**Technical Review of the Farmington Mancos-Gallup Draft Resource Management Plan Amendment
and Environmental Impact Statement**

**Prepared by
Doug N. Blewitt
Certified Consulting Meteorologist
Air Quality Resource Management**

September 25, 2020

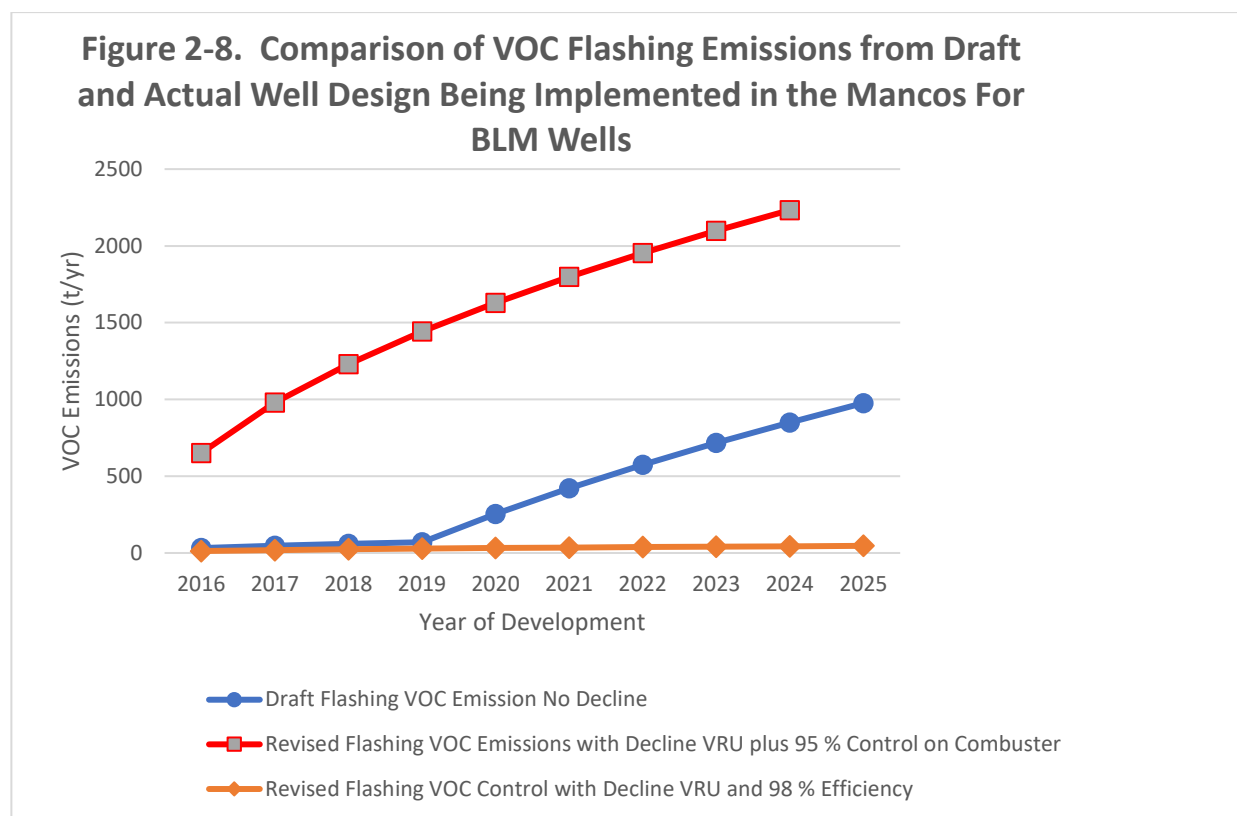
Figure 2-8 presents a comparison of flash VOC emissions as reported in the Draft EIS and the revised emissions based on current engineering for BLM wells. This figure demonstrates that estimated VOC emissions in the worst-case year 2025 are reduced by 1,483 tons/year (65 percent) because of the additional controls in place as well as oil production decline. Two cases for controlled VOCs with decline are presented. The first presents inclusion of the VRU and 95 percent control on the residual VRU gas. The control efficiency of 95 percent is based on permit conditions. The second case is the same as the first case but a control efficiency of 98 percent was used consistent with manufacturer data and test data.

In the year 2016 the difference between the two cases is a result of the inclusion of the additional reduction in emissions from the VRU. The difference in slope for the two cases between 2017 and 2020 is the cumulative effect of the VRU and oil production decline. It was assumed in 2020 that oil production had declined to the point where the inclusion of the VRU was no longer viable because of insufficient gas to operate the VRUs. The slope of the revised case becomes similar to what was reported in the Draft EIS,

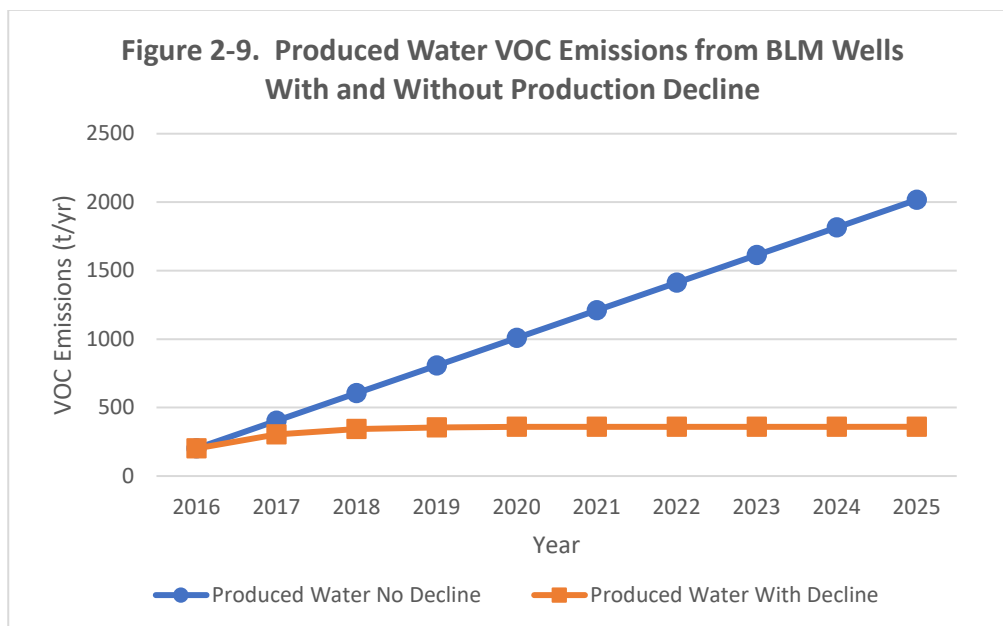
Figure 2-9 illustrates the importance of the inclusion in decline in the produced water calculations. VOC emissions were reduced from 2,017 tons/year to 360 tons/year (82 percent reduction). These calculations are conservative because they do not assume that produced water emissions are routed to the combustor.

- Reduction in VOC emissions resulted from inclusion of decline in produced water
- Draft EIS assumed a constant 11,000 bbl/year/well

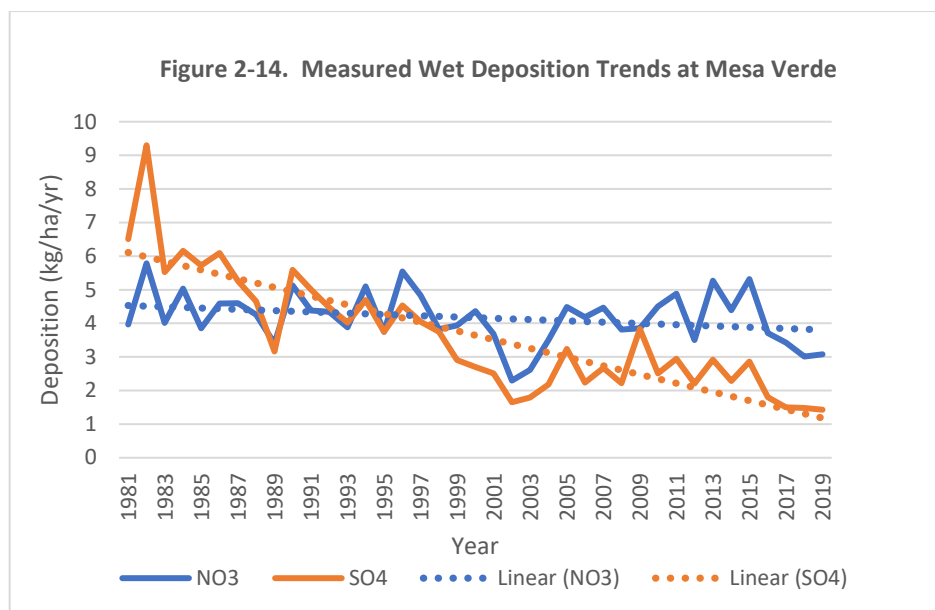
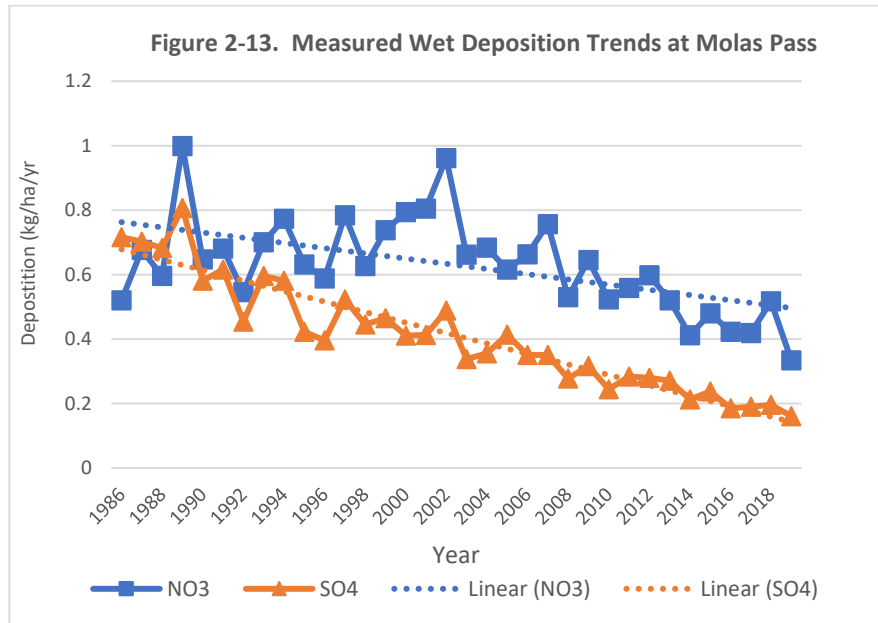
In terms of nitrogen deposition, monitoring data from Molas Pass, CO, Mesa Verde, CO and Badlander, NM³⁴ indicate substantial decreases in deposition data from 1990 through 2013 (Figures 2-12 and 2-13 respectively).

These figures do not illustrate the increase in deposition indicated in the Draft EIS prior to 2006. Rather, over the period of record at these three sites there has been a dramatic decrease in SO₄ deposition and a slight decrease in NO₃ deposition.

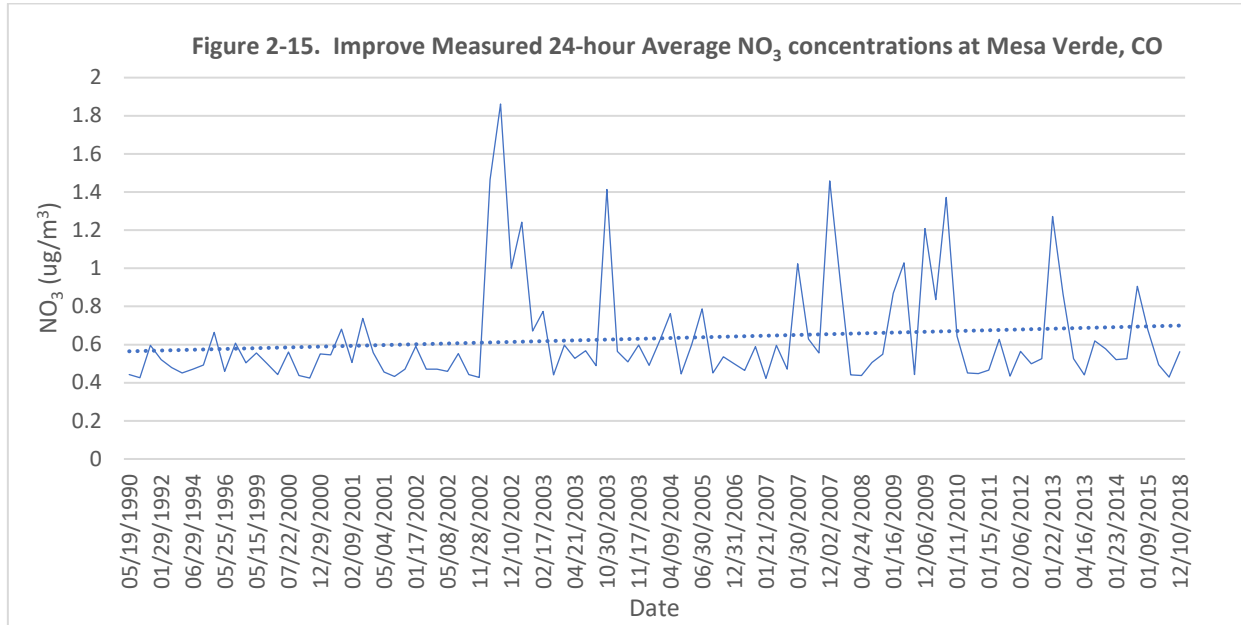
Figure 2-15 presents IMPROVE measured NO₂ concentrations at Mesa Verde between 1988 through 2018. This figure does not illustrate any trend in NO₃ ambient concentrations. It does appear that peak concentrations have tended to be smaller from 2014 until 2018 than for the period 2000 through 2014. From 1988 until 2014 peak concentrations appear similar to those measured in 2014 until 2018.

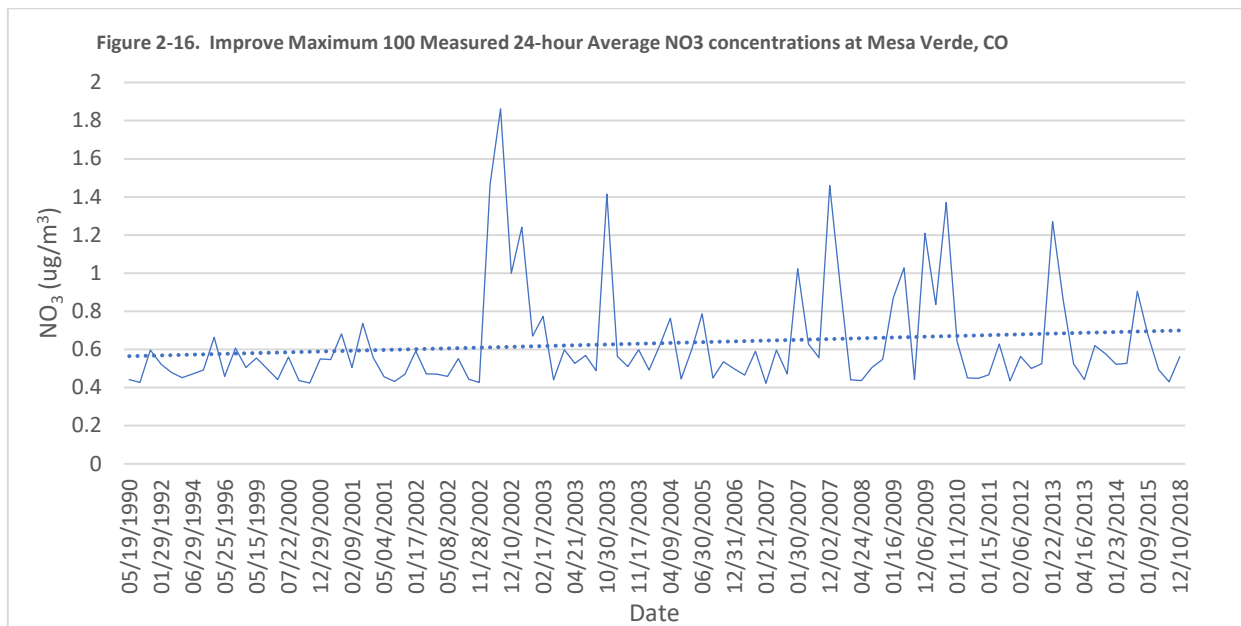
Figure 2-16 presents the top 100 measured concentrations over the period of record at Mesa Verde. There is no apparent change in maximum concentrations after controls were installed on the power plants in 2016.

Figure 3-1.

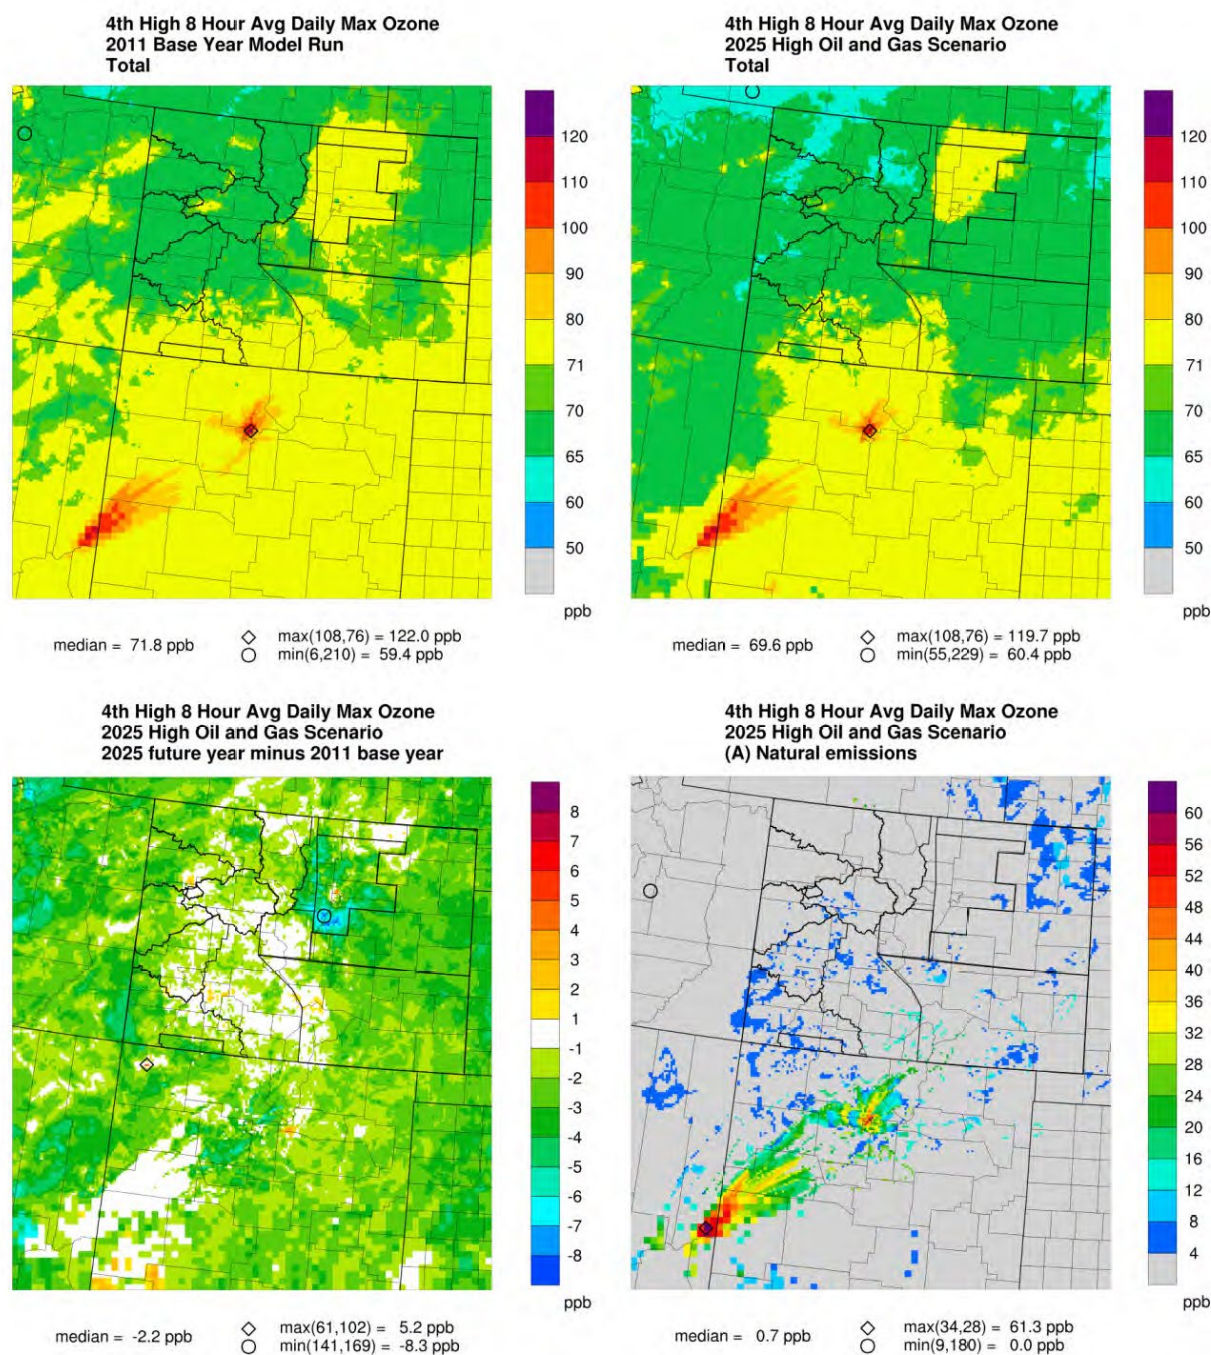
The top left plot is for the 2011 Base Case. It is apparent in the figure that there are two major emission sources, one in northern New Mexico and the other on the border of New Mexico and Arizona, and these result in large isolated ozone impacts. The report states that these large impacts were from natural sources (wildfires).

The upper right plot presents cumulative impacts for the maximum oil and gas scenario for the year 2025. It is apparent in this figure that the 4th highest ozone concentration in the western portion of the grid (Mancos Shale area) has lower impacts than the base case. The bottom left figure presents the difference between the 2025 maximum oil and gas development case and the baseline case. This figure presents overall predicted ozone impacts from the maximum oil and gas development case which are projected to decrease (improvement in air quality) compared to the baseline simulation.

The improvement in ozone levels is further supported in the bottom left figure that presents the difference in predicted ozone between the maximum oil and gas case and the baseline and indicates that for the majority of the modeling domain, ozone concentration decreased between 1 and 4 ppb. There is a very small isolated area in northwest New Mexico where there is a 5 ppb increase in ozone. The report indicates that the largest increase in the maximum oil and gas case over the base case is 1.4 ppb. Therefore, the predicted 5 ppb increase is not caused solely by the Mancos sources.

The bottom right figure presents the 4th highest ozone concentrations resulting from natural sources. This figure indicates the strong dominance of natural sources on the Arizona and New Mexico border as well as in the northern portion of central New Mexico. The figure suggests that natural sources may be responsible for the 5 ppb increase in northwest New Mexico.

Figure 3-2.

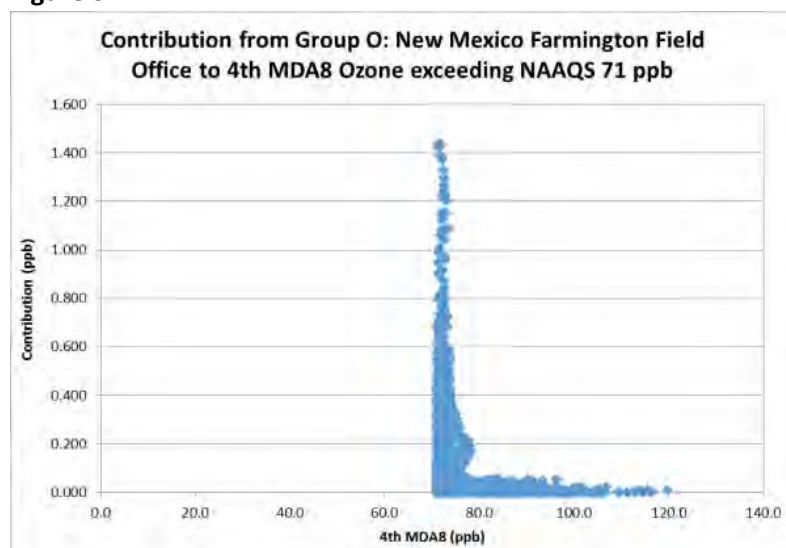
The information included in these figures is incomplete because it provides no information on the number of grid cells that have total MDA8 concentrations above 71 ppb or the frequency distribution for maximum oil and gas impacts. The figure does indicate that as total predicted ozone concentration increases above 71 ppb, the oil and gas impact decreases.

Figure 3-27. Differences in eighth highest (98th percentile) daily maximum 1-hour average NO₂ concentrations between the 2025 emission scenarios and the 2011 Base Case for the 2025 High (top left), Low (top right) and Medium (bottom) Development Scenarios.

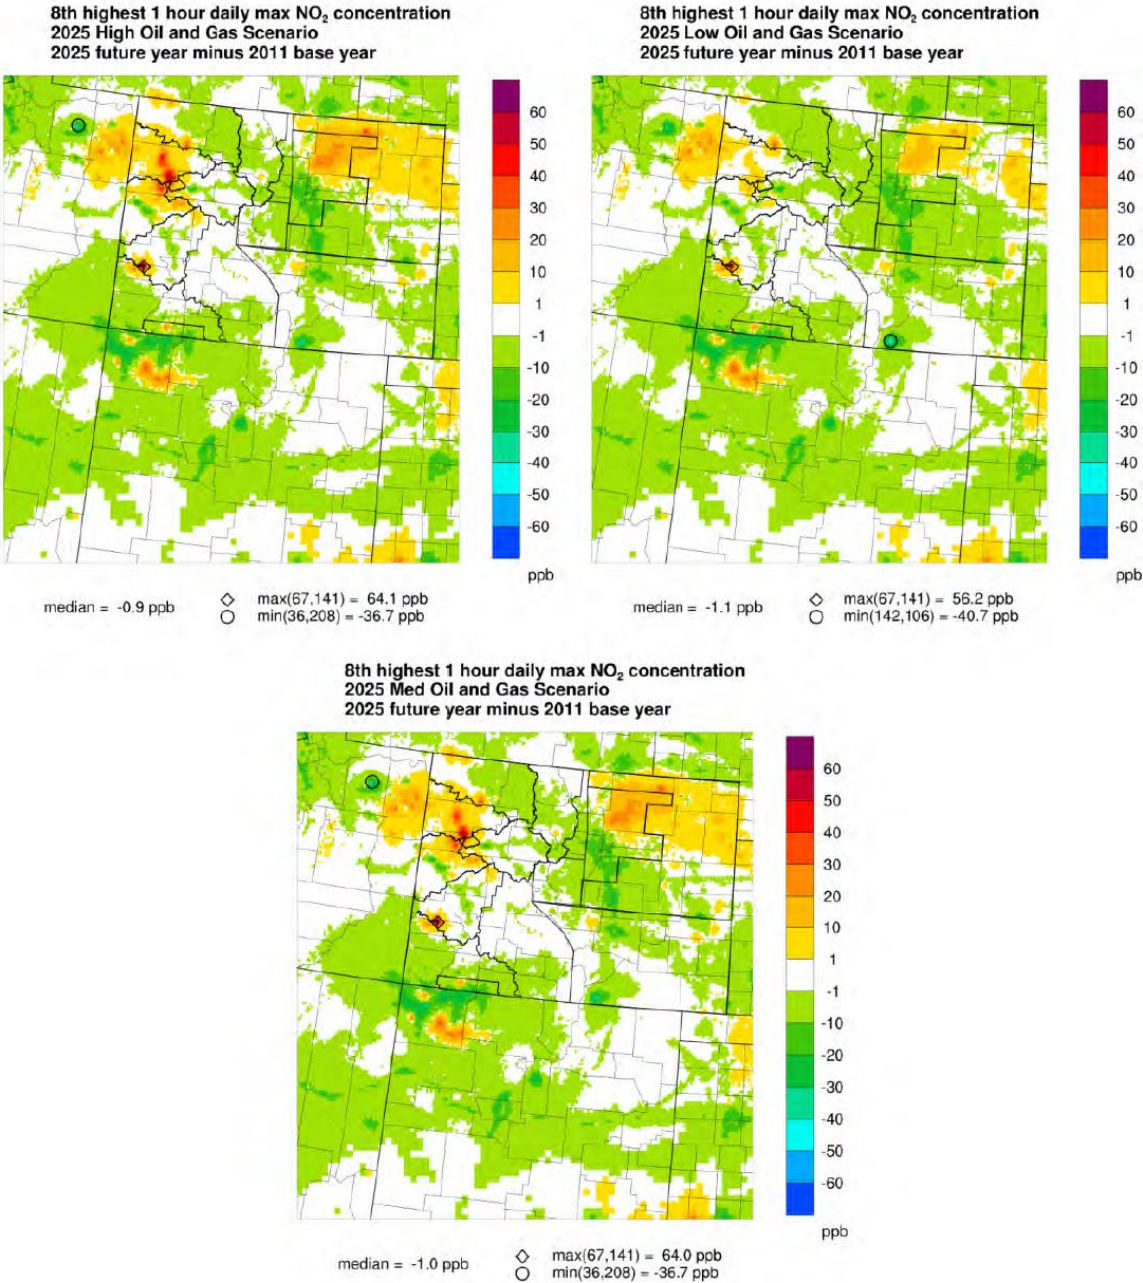
Because of the spatial scale of the plots in the report, it is not possible to accurately determine the 1-hour NO₂ concentrations in the Mancos region. If the differences between the base case and the 3 development cases are examined (Figure 3-6), there is indication that the area of maximum impact is in Colorado and likely not affected by Mancos sources. It appears there is a slight increase in NO₂ impacts for the three alternatives compared to the base case. Figure 3-7 presents the contribution from Mancos sources for the three development cases and the maximum NO₂ impacts are:

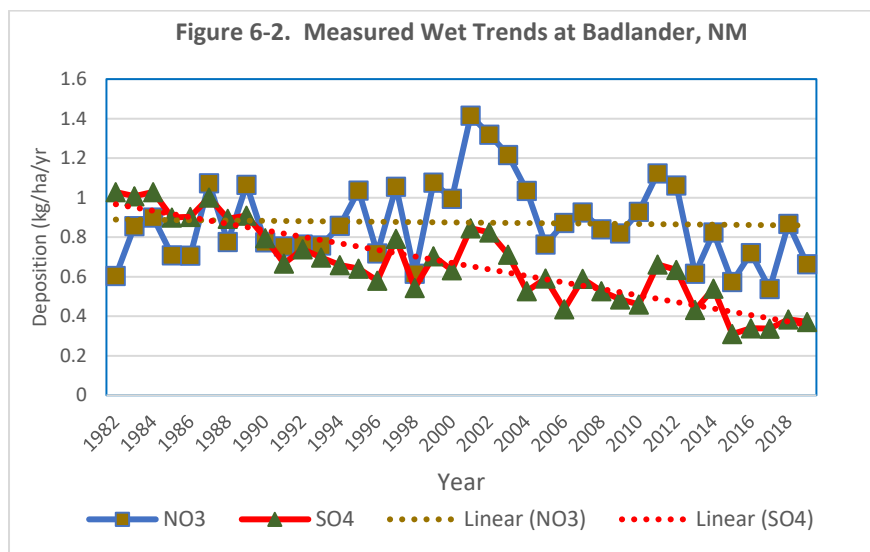
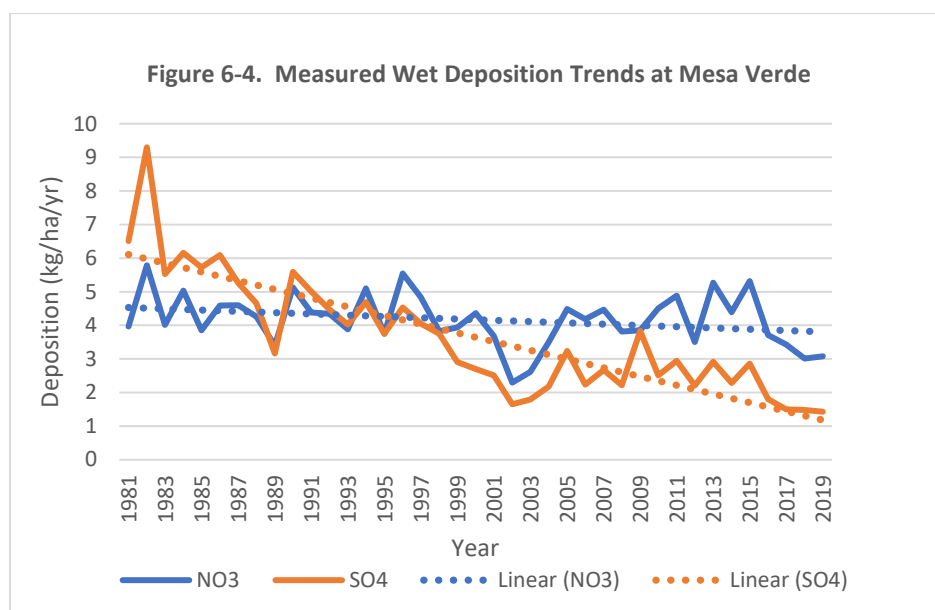
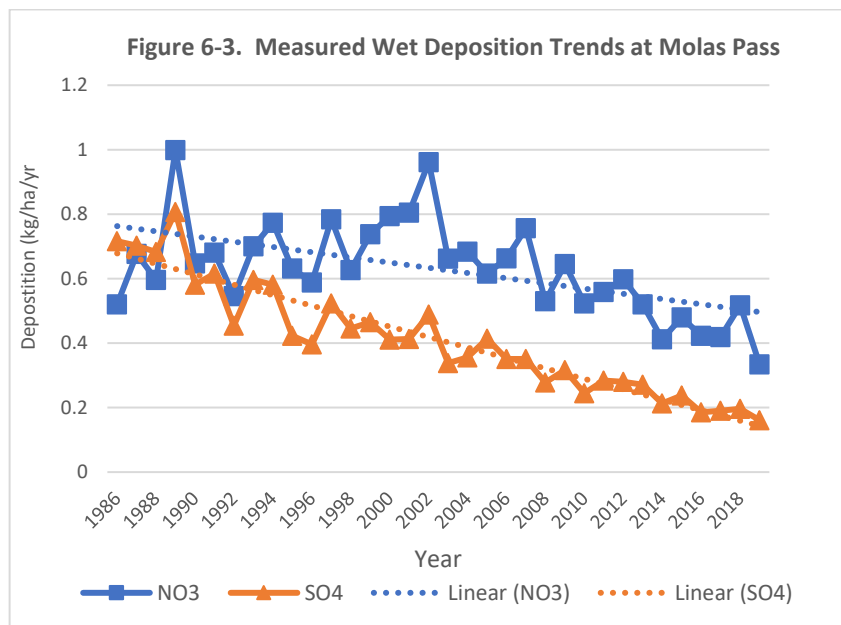
Figures 6-2 through 6-4 present nitrogen and sulfur deposition trends at CASTNet monitors in the vicinity of Mancos Shale Development.

These figures indicate the dramatic decline in sulfur deposition over the period of record (approximately 30 years) at all three areas and also a decline in nitrogen deposition at all three sites. These figures clearly indicate that deposition to sensitive areas has been reduced over the last 30 years.
